MOUNTING OF HAND SET HANGERS

This addendum supplements Section B502.321, Issue 2, as follows:

FIG. 5
MOUNTING INFORMATION

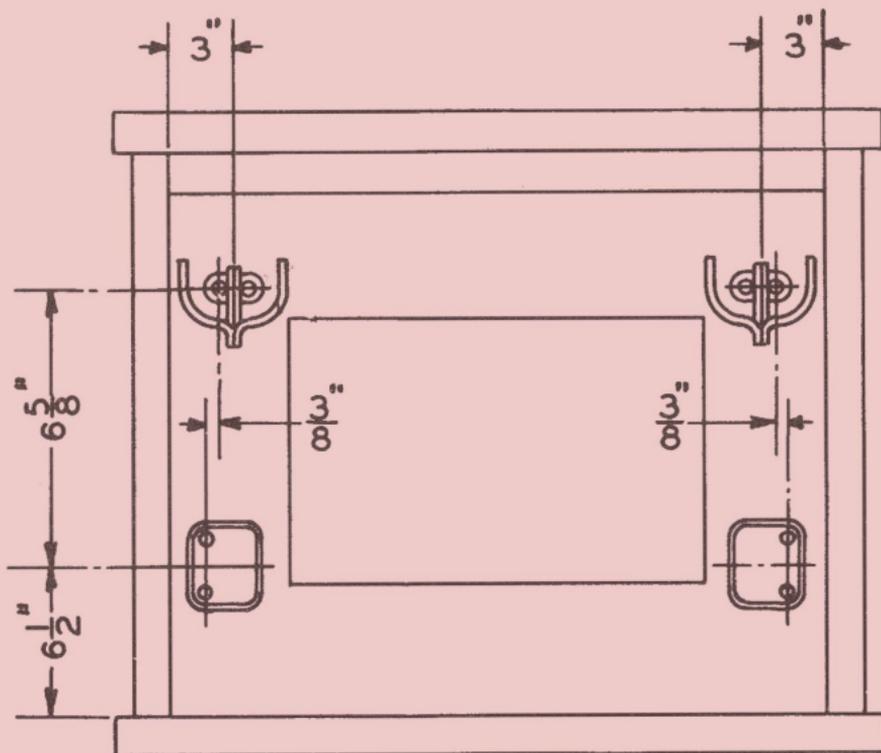
3.07 Drill end of order turret and mount as indicated by Fig. 1 of the section and Fig. 5 of this addendum.

FIG. 6

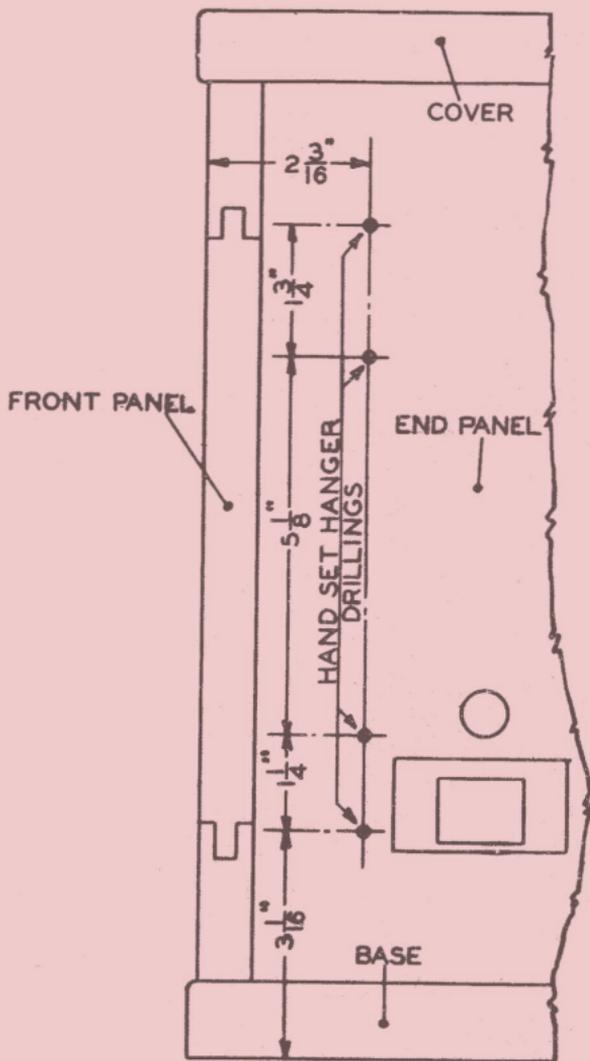
3.08 Drill end panel of order turret and mount as indicated by Fig. 6 of this addendum.

FIG. 7

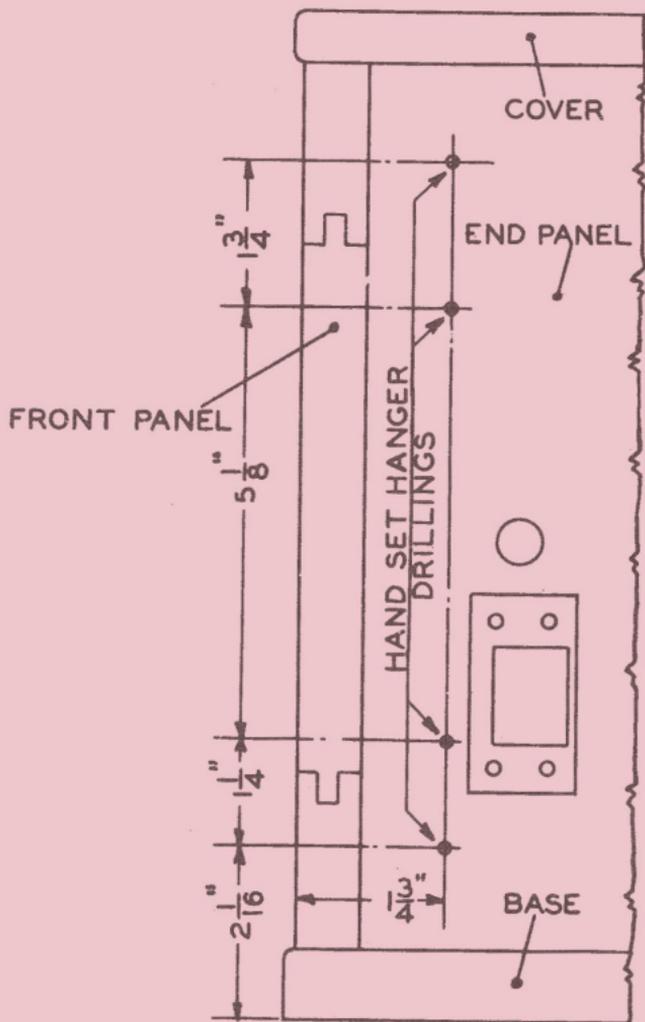
3.09 Drill end panel of order turret and mount as indicated by Fig. 7 of this addendum.
